Laguna Madre Water District
Wastewater Treatment Plants Rehabilitation
 September 2016

Isla Blanca WWTP
Site Plan And
Mechanical Modifications
To Existing Plant

Laguna Vista WWTP
Chlorine System Feed/Blower
Building Mechanical Modifications

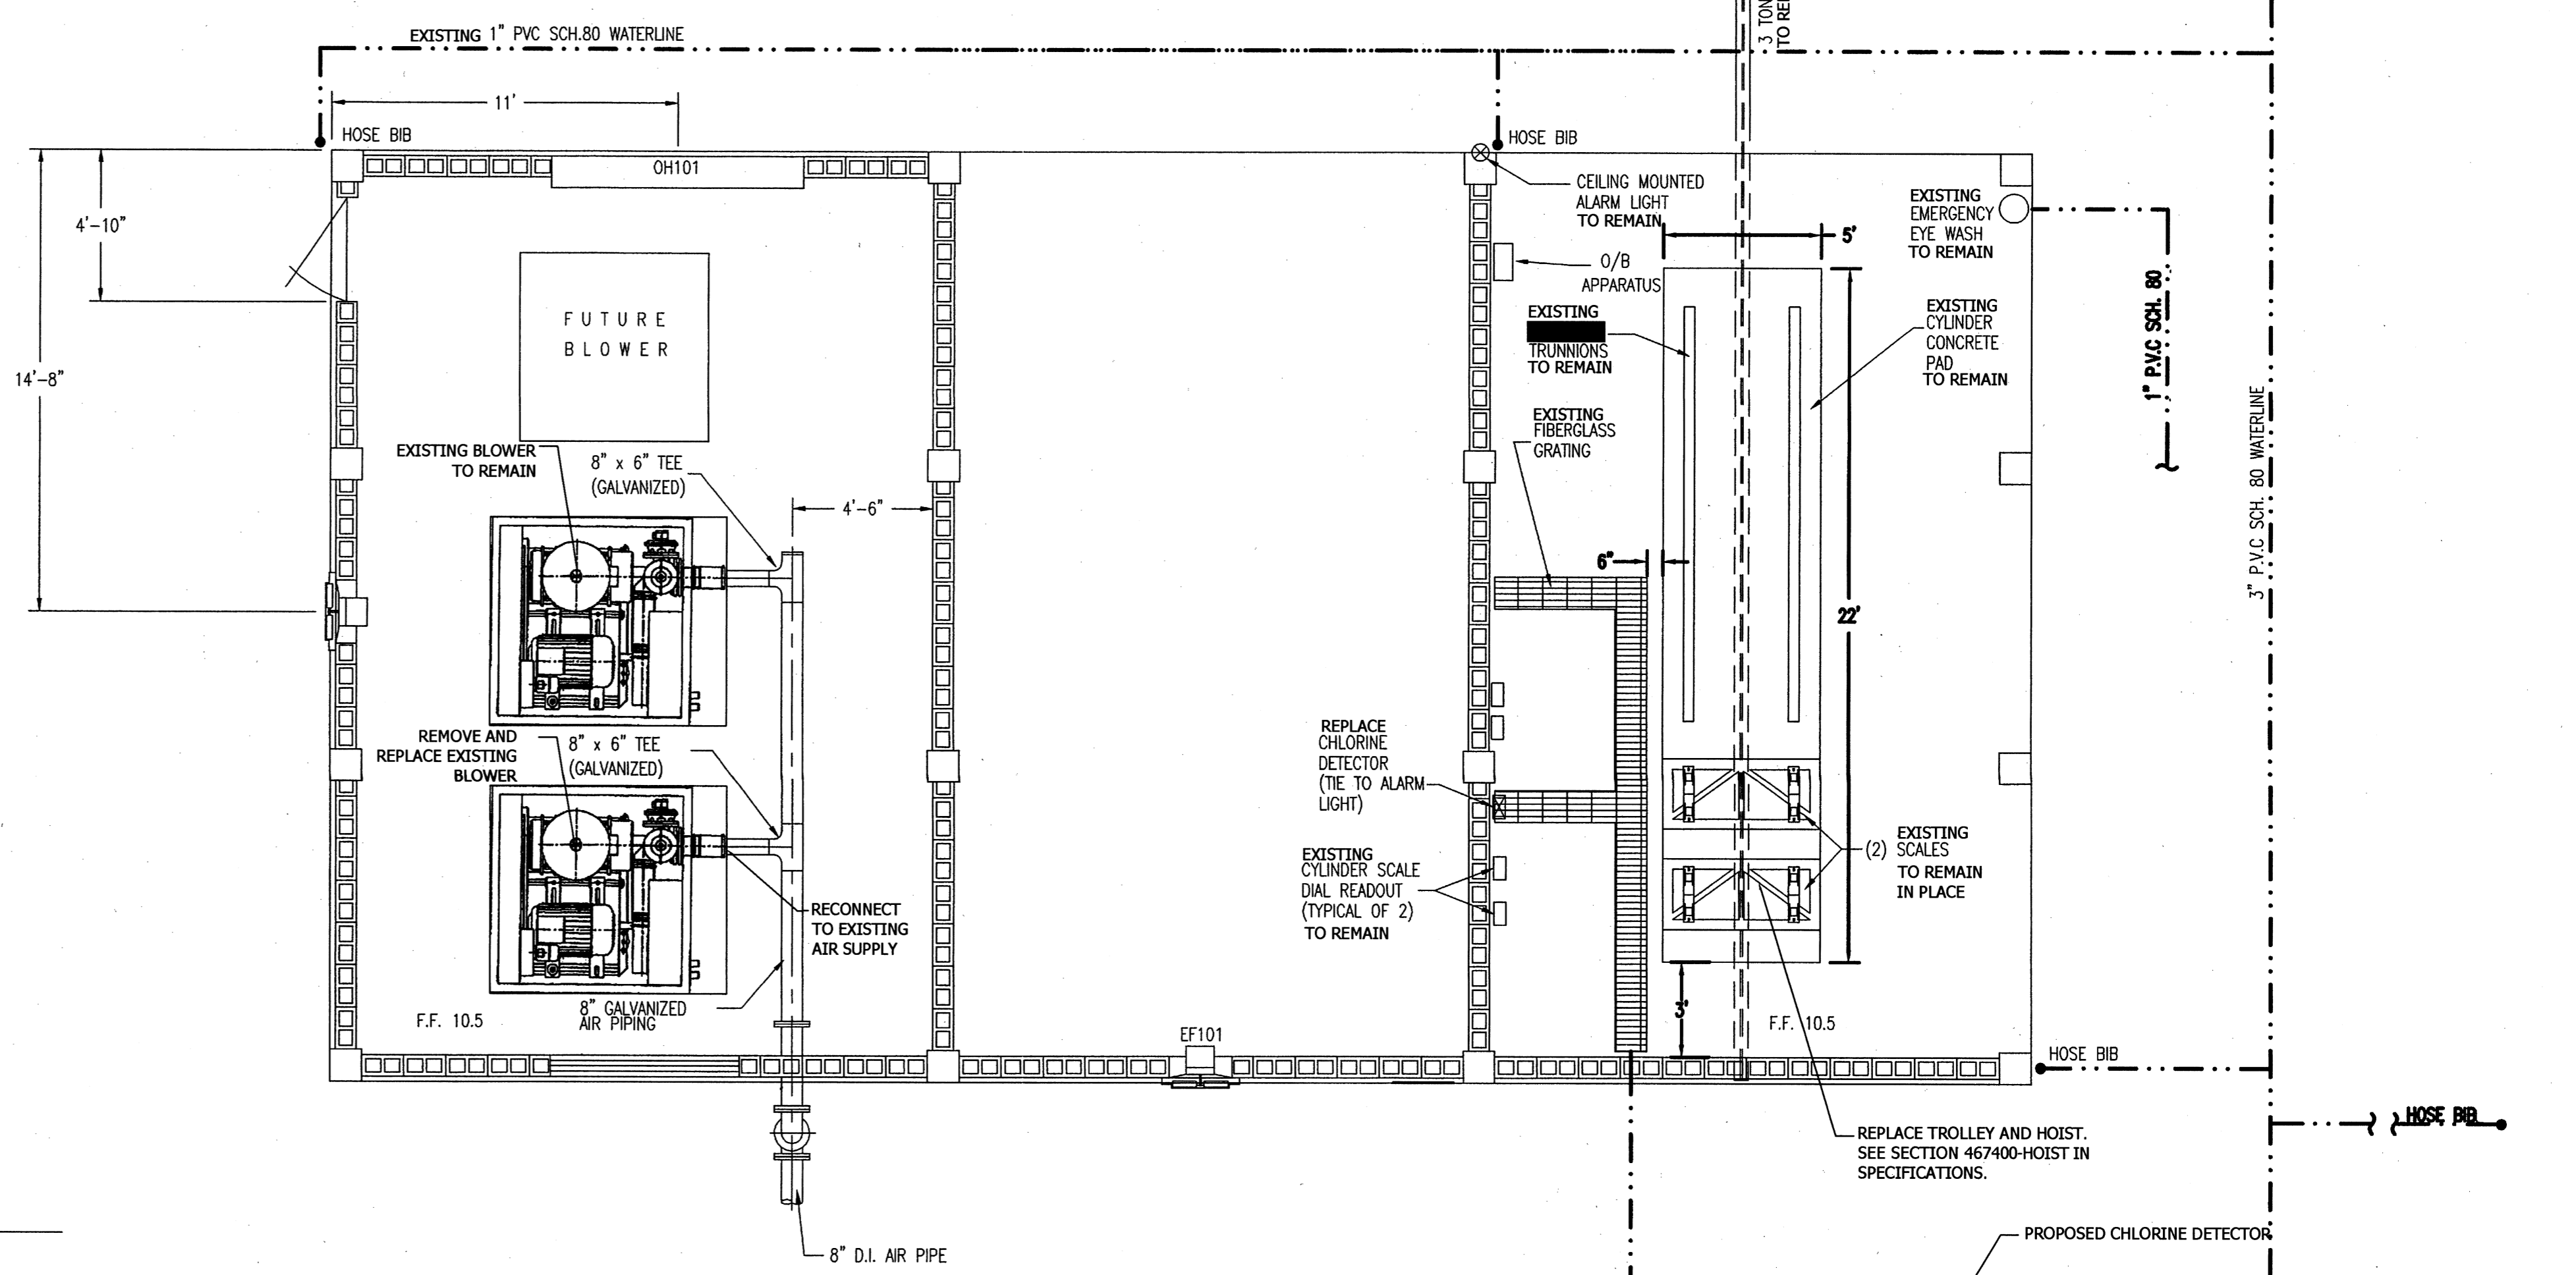
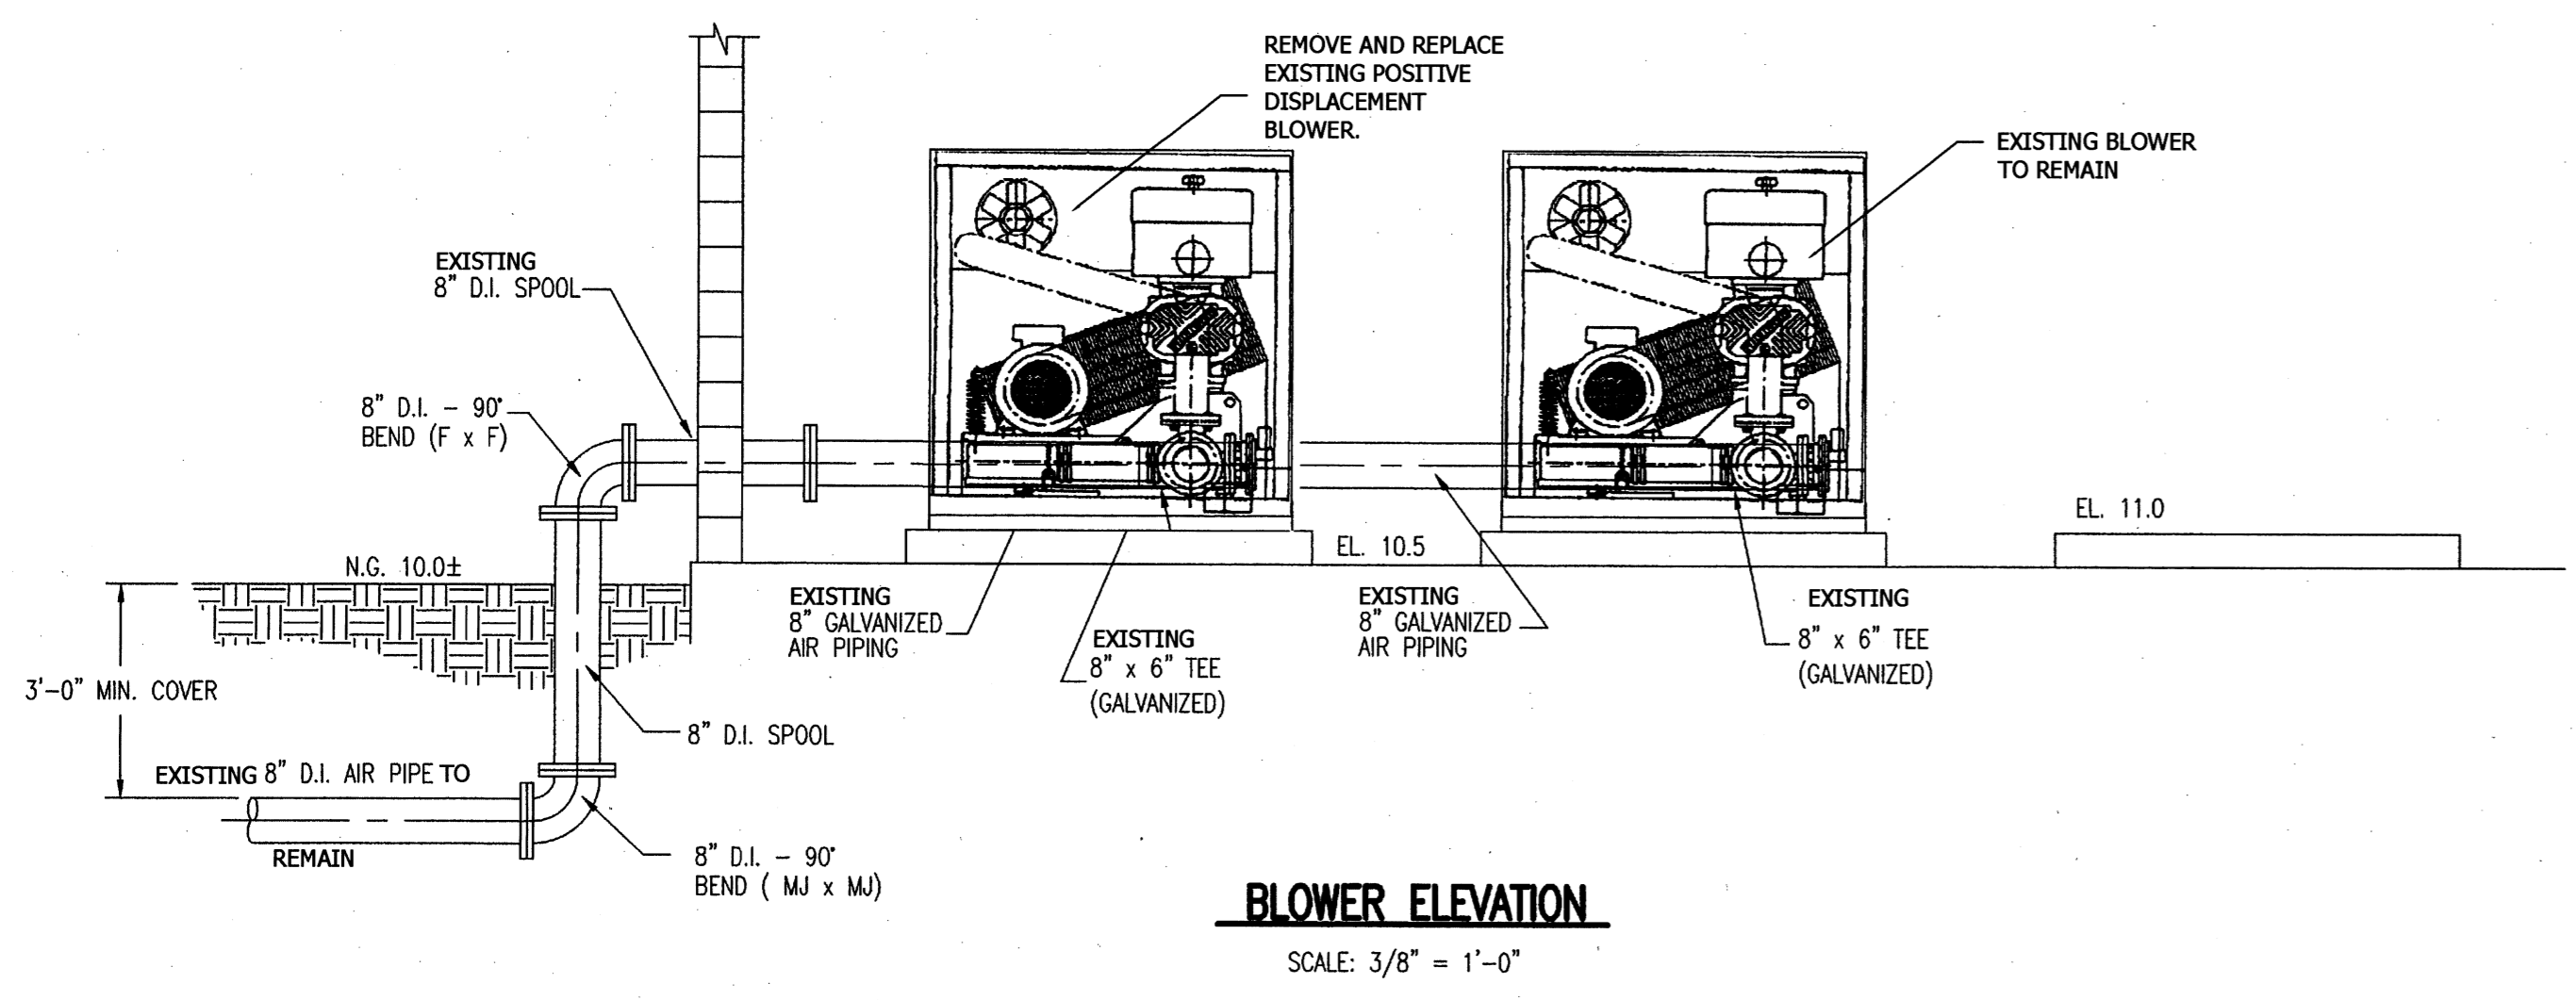
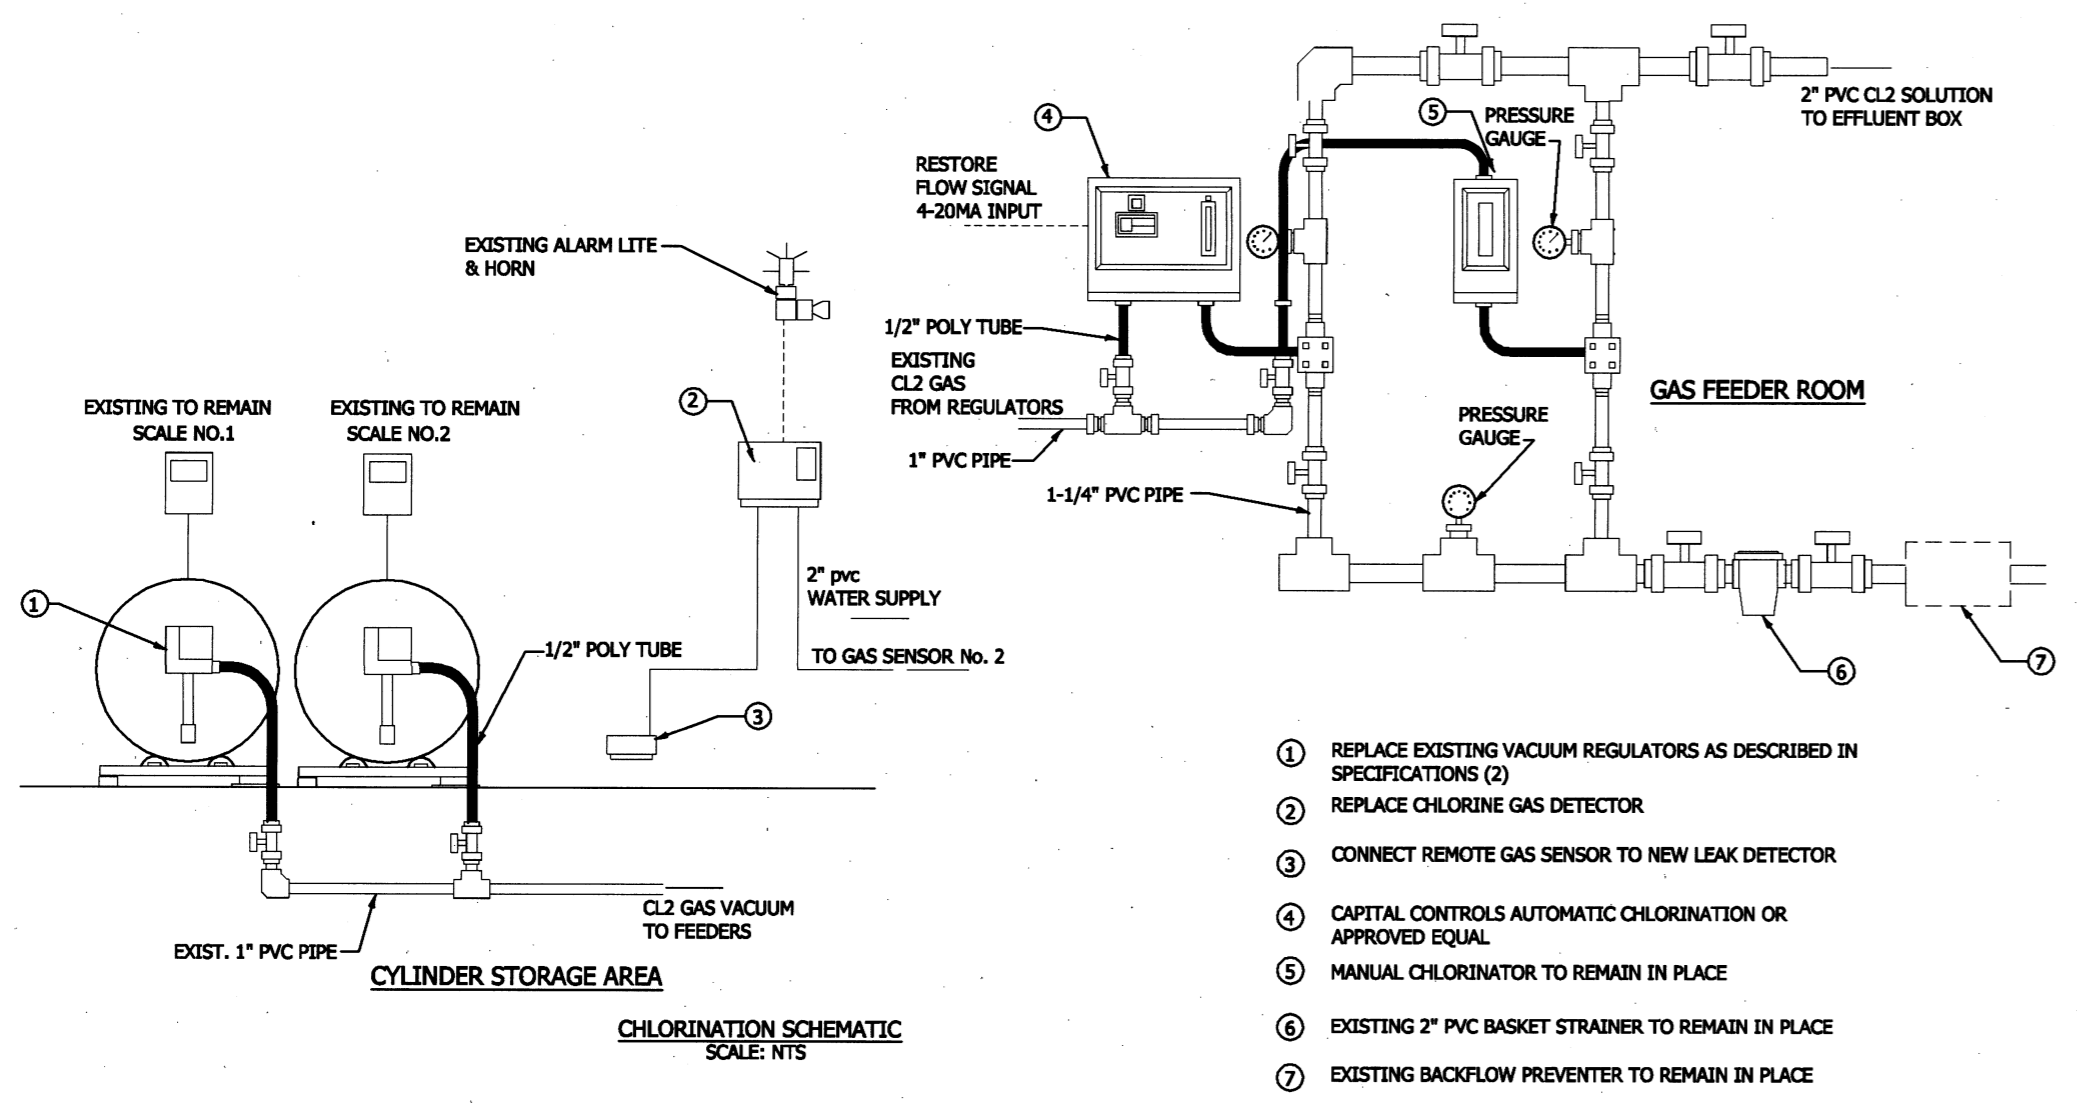
NOTES
ADDENDUM No.1: REVISED PROPOSED HIGH SPEED TURBO BLOWER, MODEL No. TO NX30-C050 OR APPROVED EQUAL PROVIDE DUAL SENSOR FOR CHLORINE LEAK DETECTOR.
